Architectural Review Board Agenda
4:00 PM Wednesday, July 2, 2025
Sussex Civic Center – Committee Room Second Floor

TO: Architectural Review Board
FROM: Gabriel Gilbertson, Community Development Director
RE: May 7, 2025 Architectural Review Board
DATE: Friday, June 27, 2025

- I. **Roll call.**
- II. **Consideration and possible action on the ARB minutes of April 2, 2025.**
- III. **Discussion and possible action on a Plan of Operation, site plan, landscape plan, architecture plan, and lighting plan for Scooter's Coffee located at the southwest corner of Business Dr and State Highway 164.**

Scooters Coffee has submitted an application to construct a 678 square foot drive-through coffee shop in the Highlands Business Park. The site is zoned BP-1 Business Park District with a PDO allowing for uses permitted in the B-2 Regional Business District. The proposed use is permitted per Section 17.0417(1)(b).

SITE PLAN

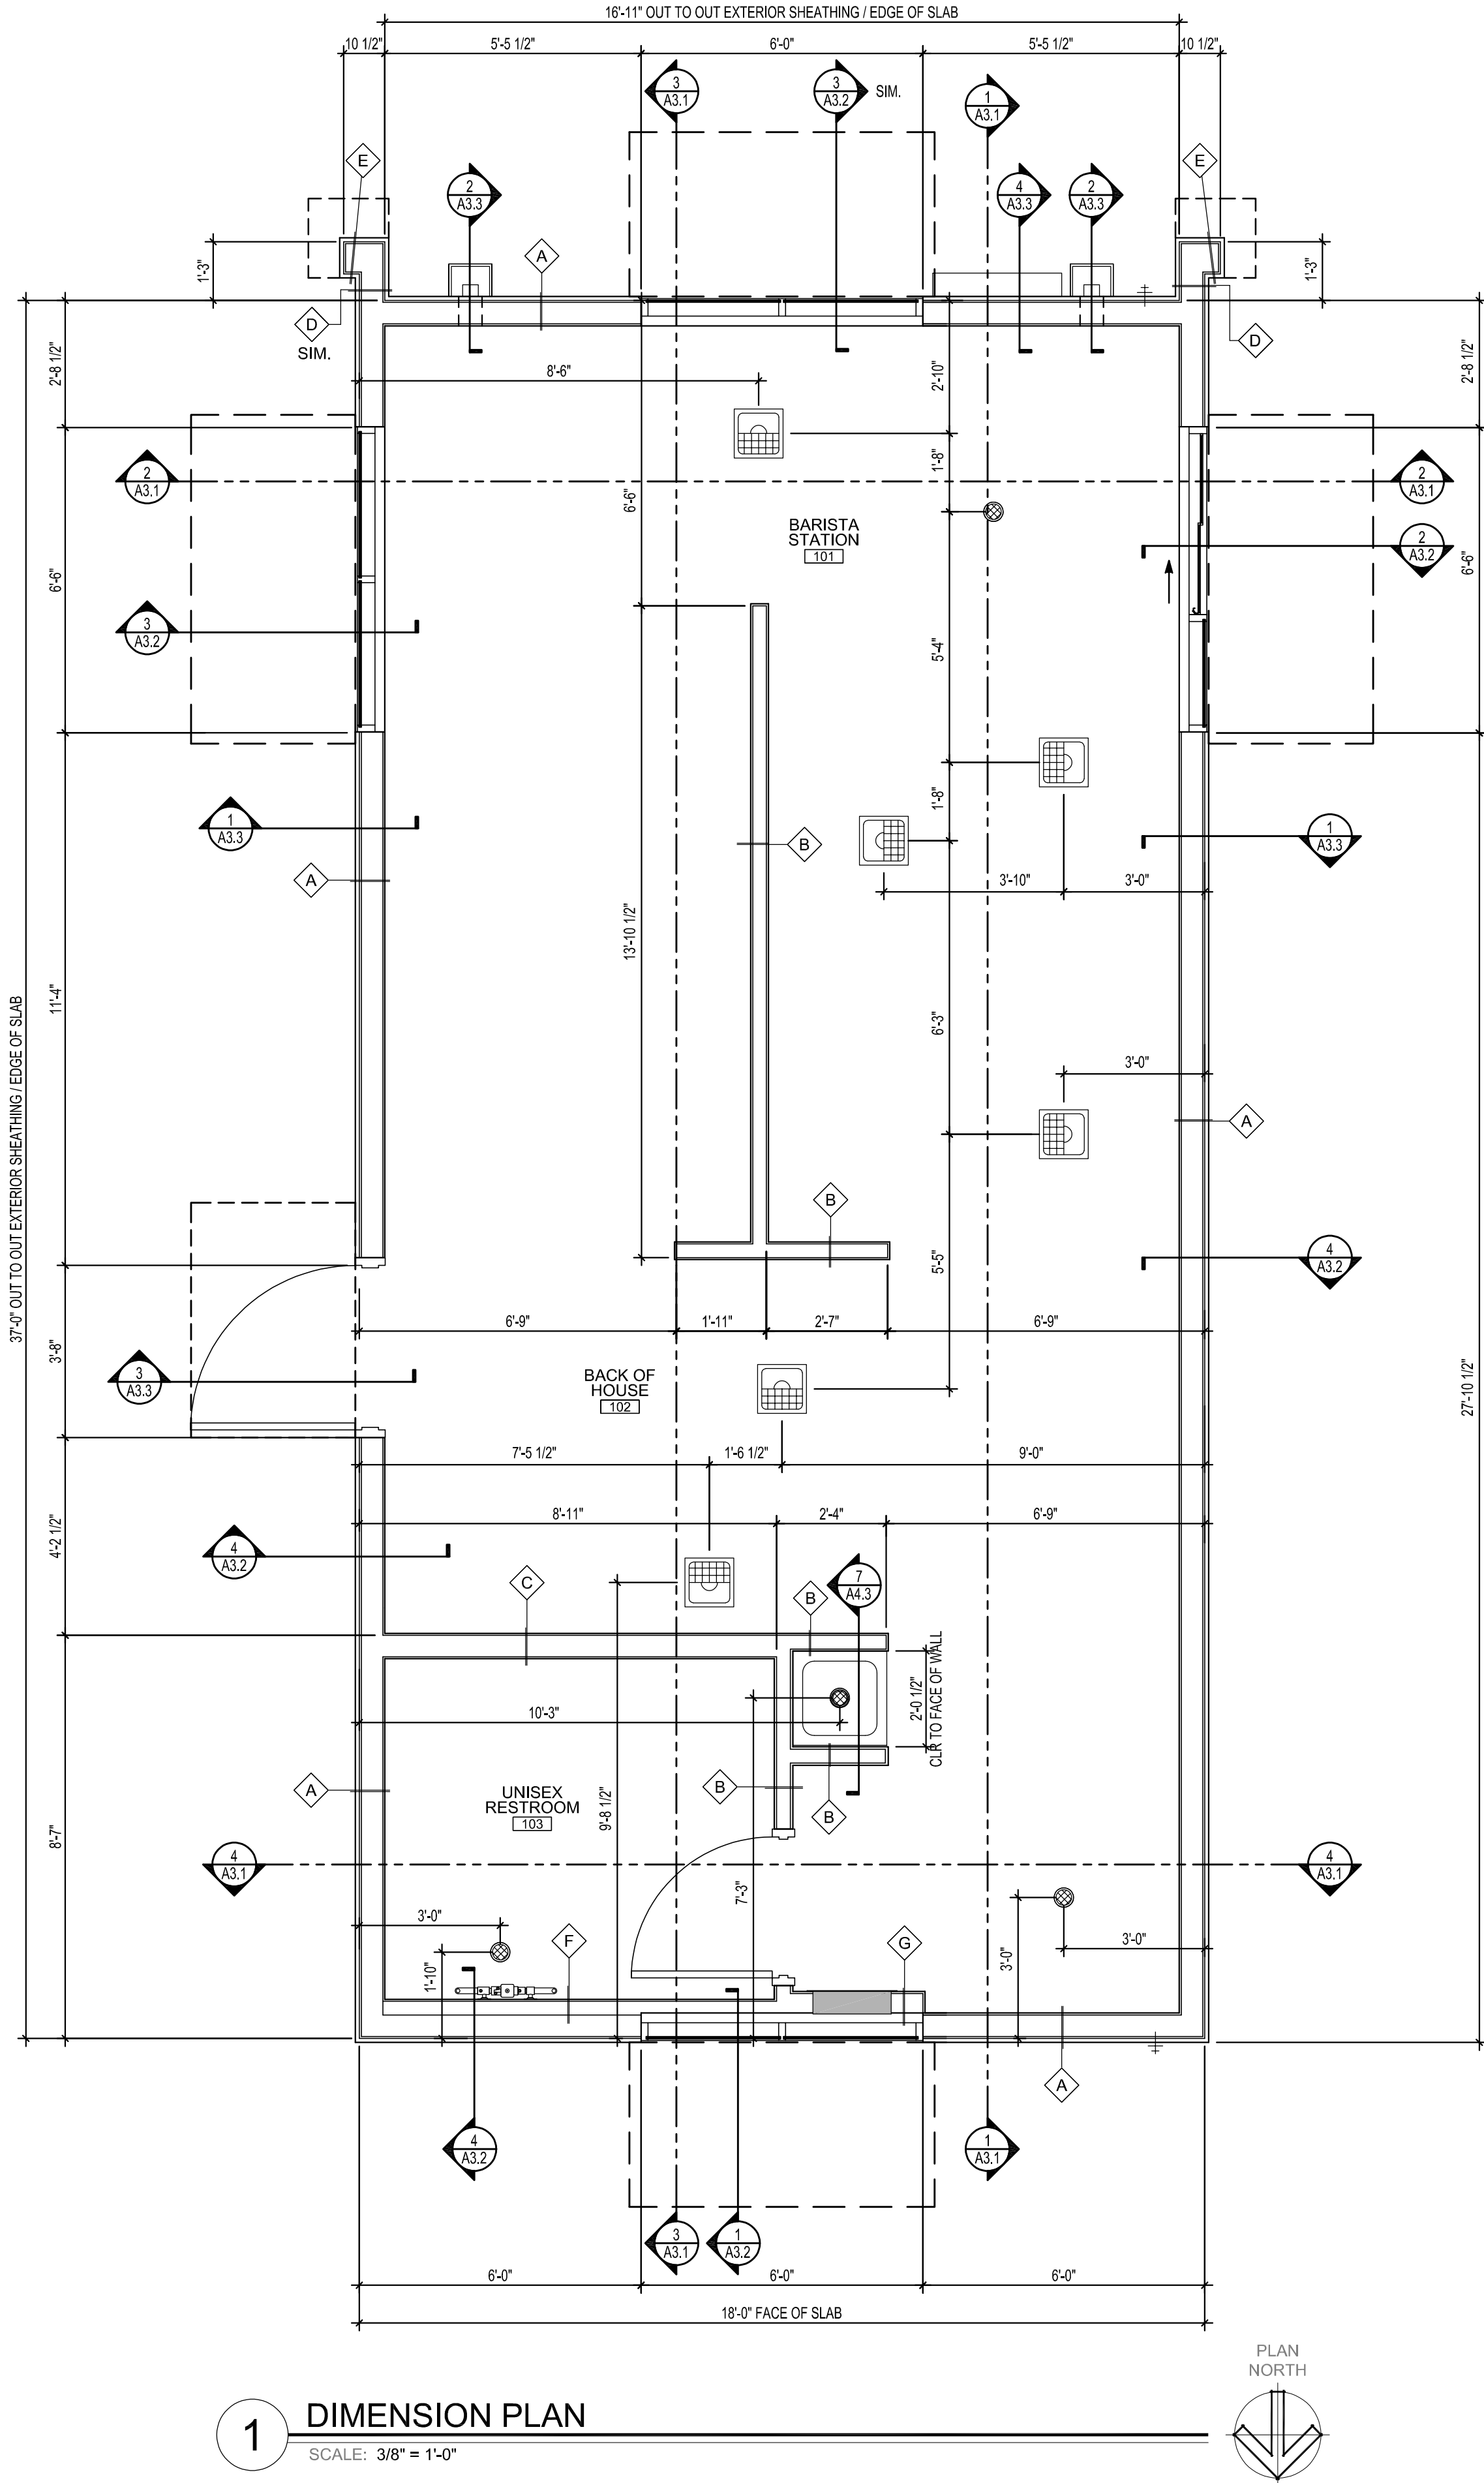
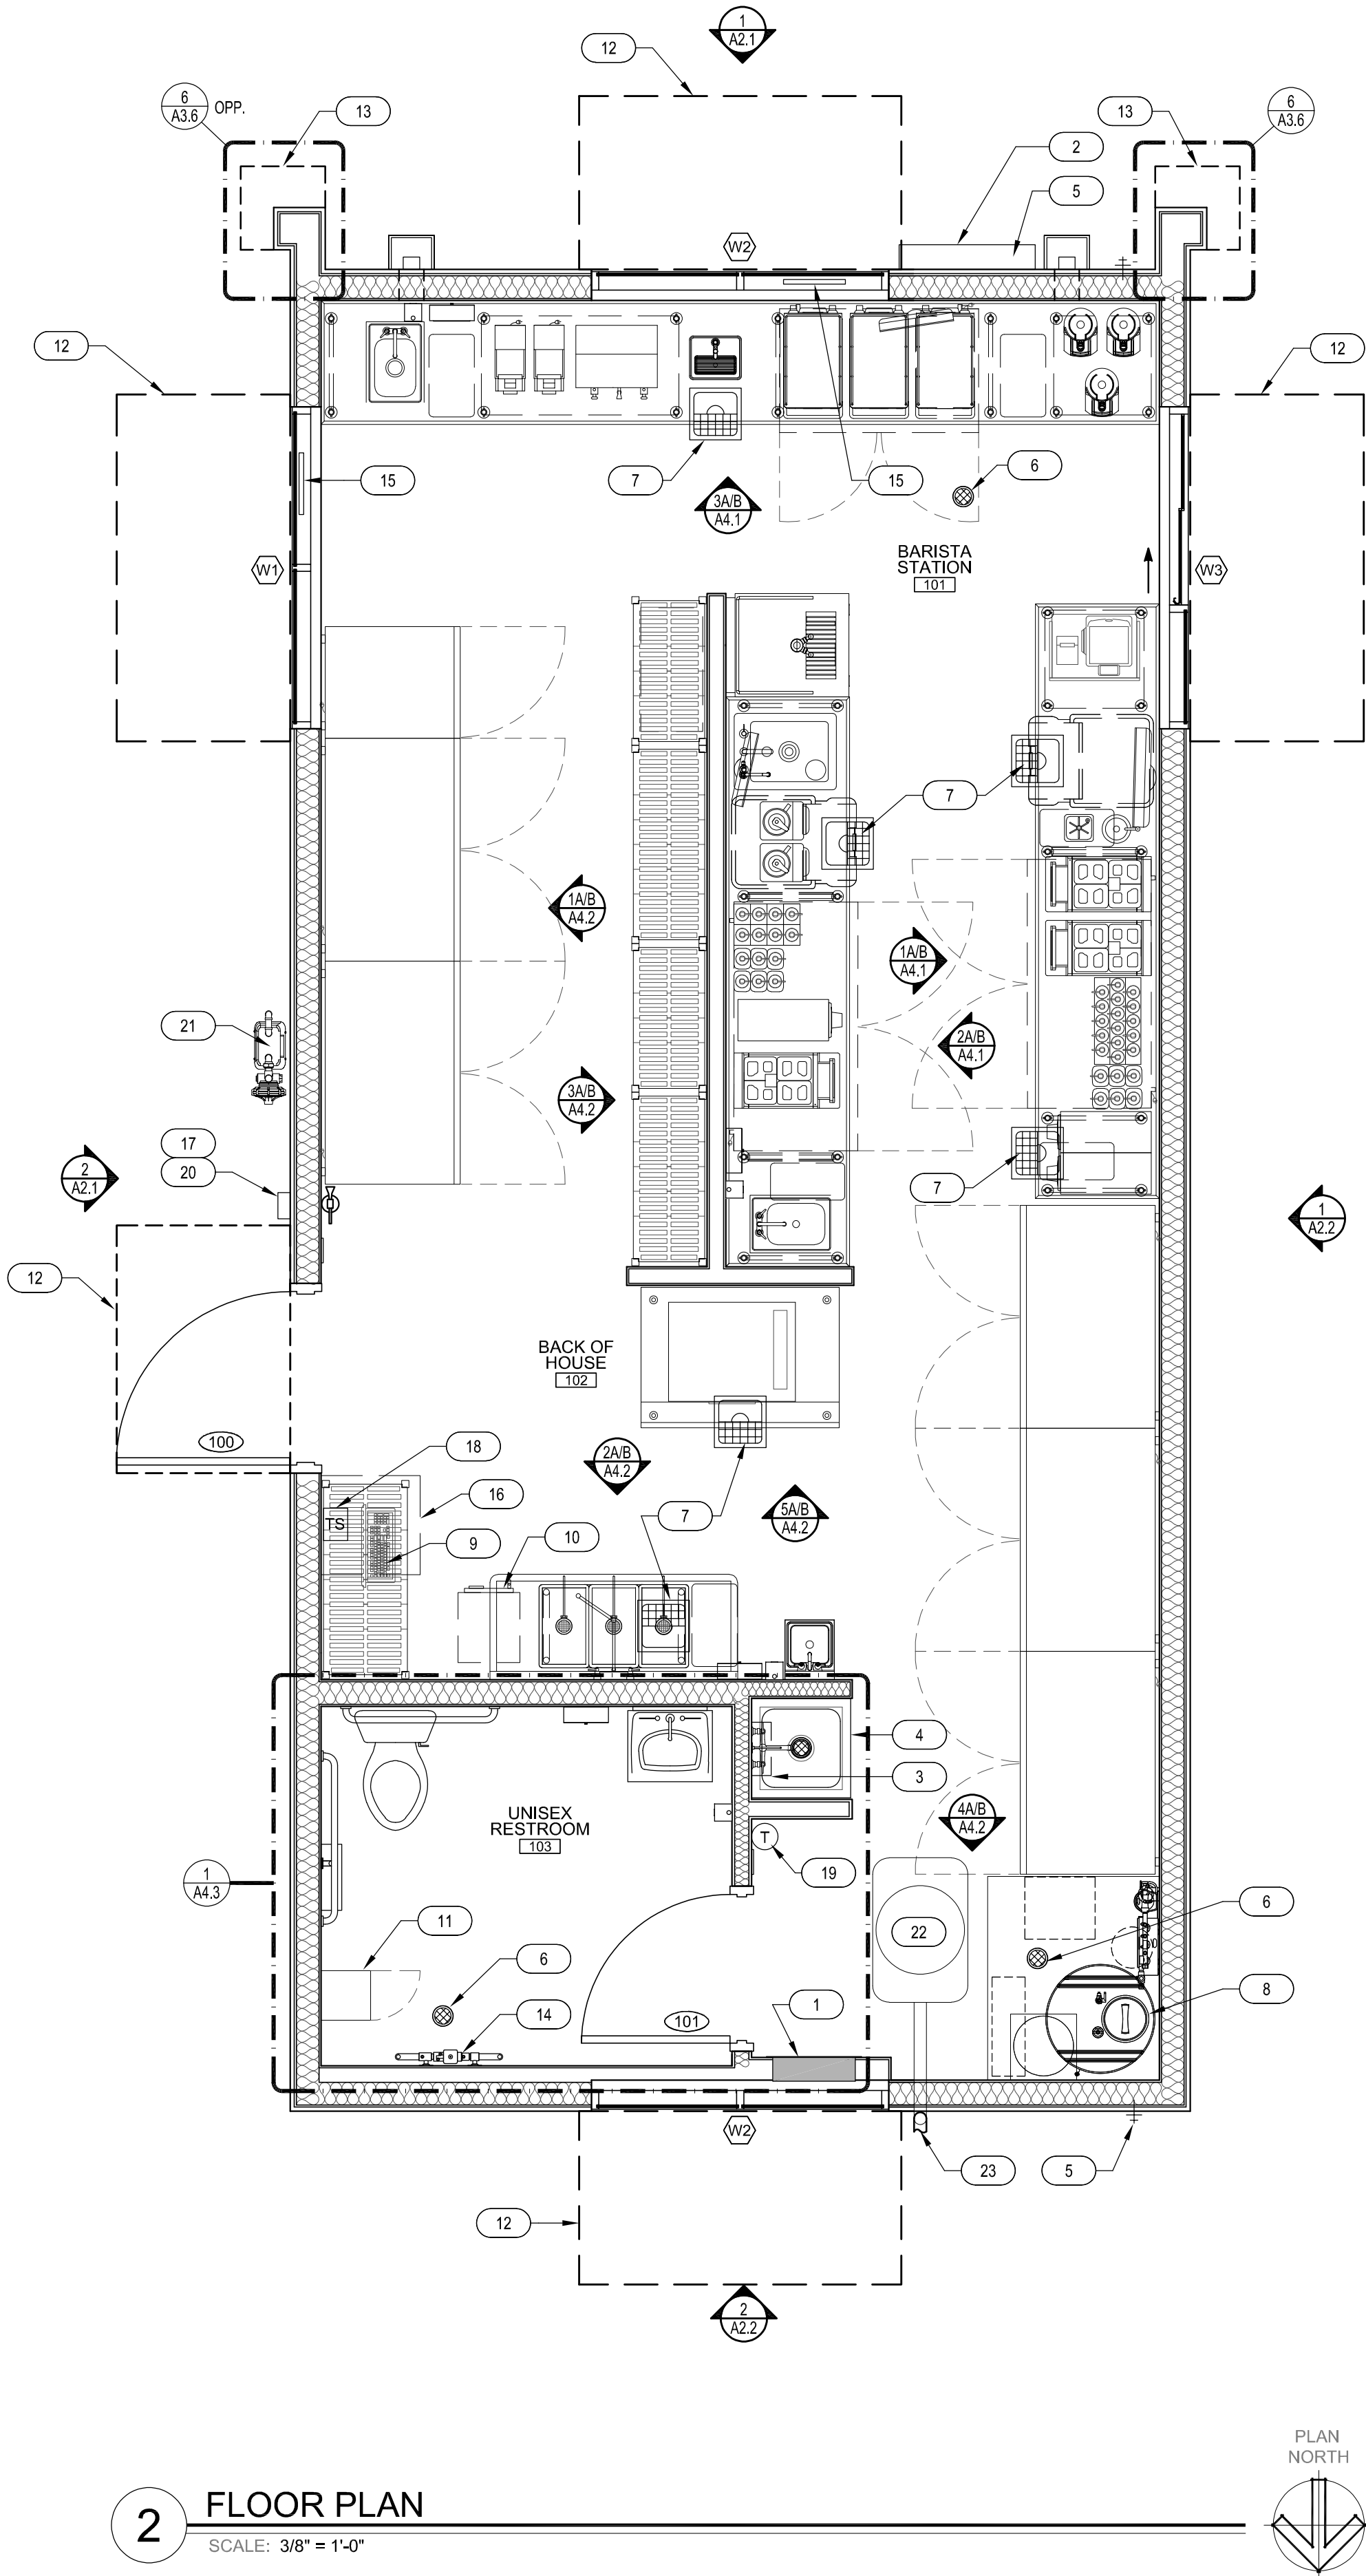
- Green space requirement is met at 65.9%.
- Site to have 7 parking stalls and will meet the minimum code requirements.

Scooters Coffee

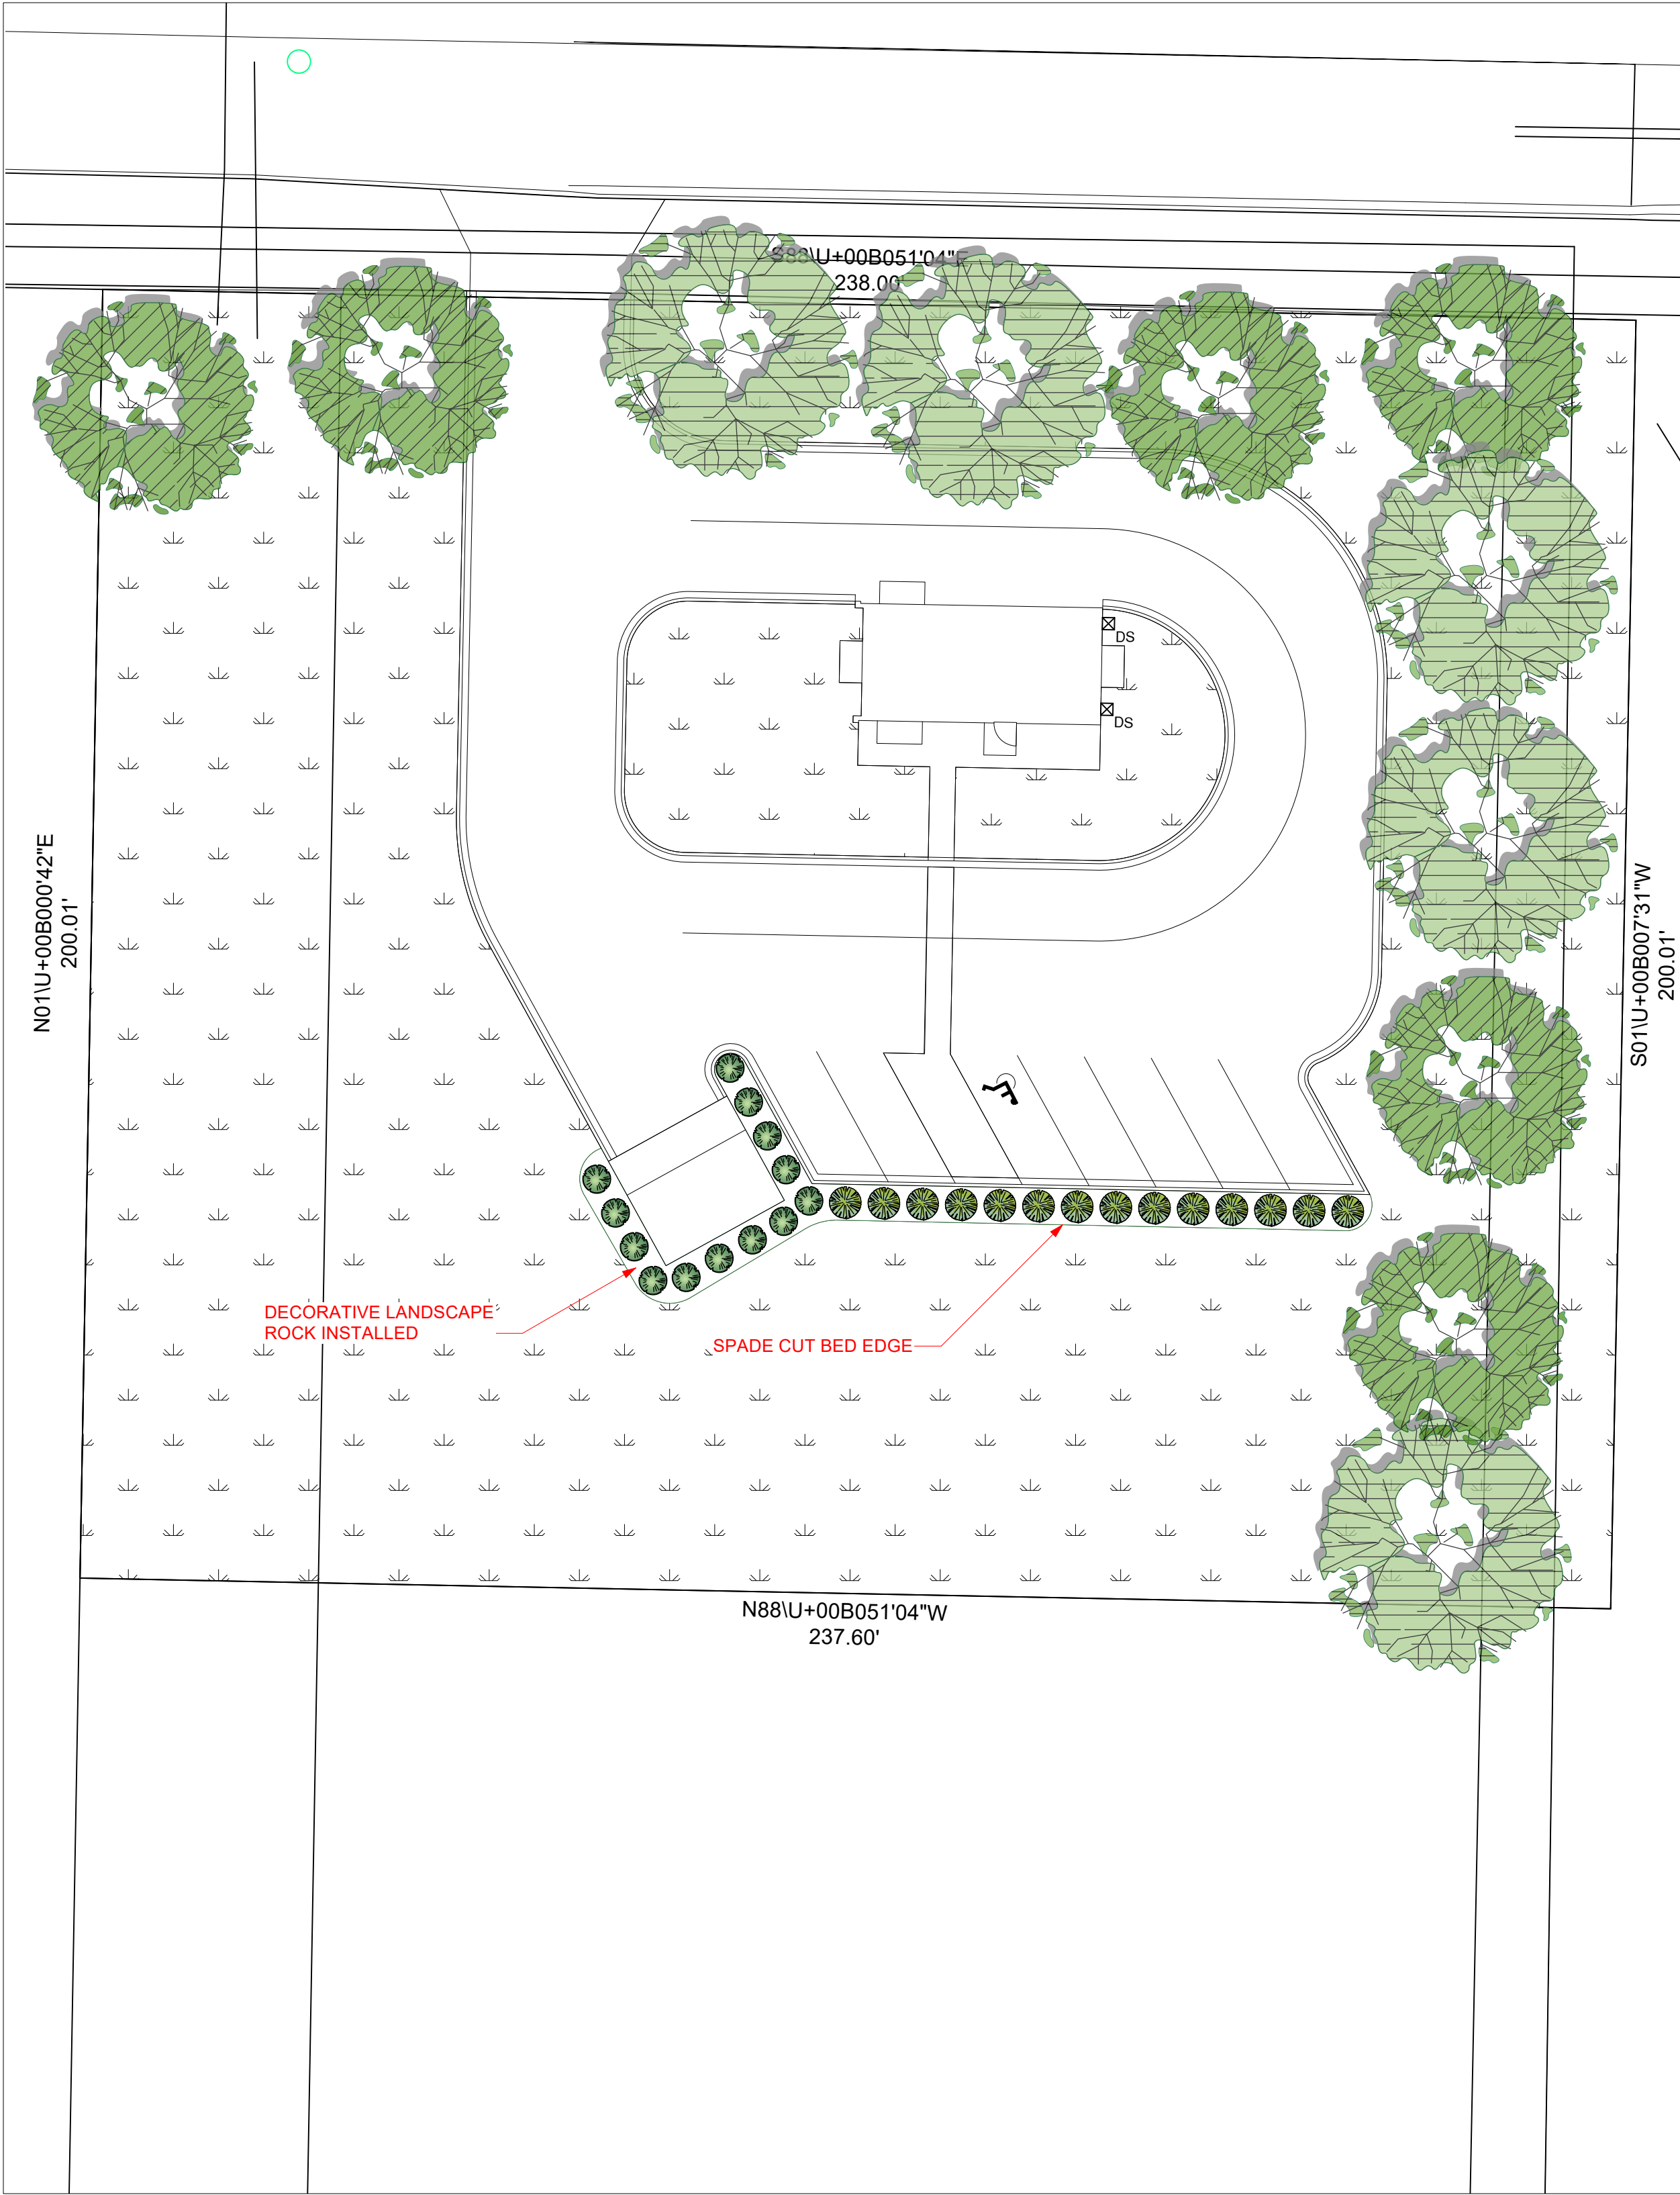
- The lighting plan meets the minimum Code requirements except that details regarding bases and fixture mounting height shall be added to the lighting plan.

1. Submitting a revised landscape plan that meets the minimum requirements of the Sussex Design Guidelines.
2. Submitting a revised lighting plan that includes details for light fixture mounting height and pole bases.
3. Compliance with the comments and conditions of the Community Development Department in the memo dated May 28, 2025.
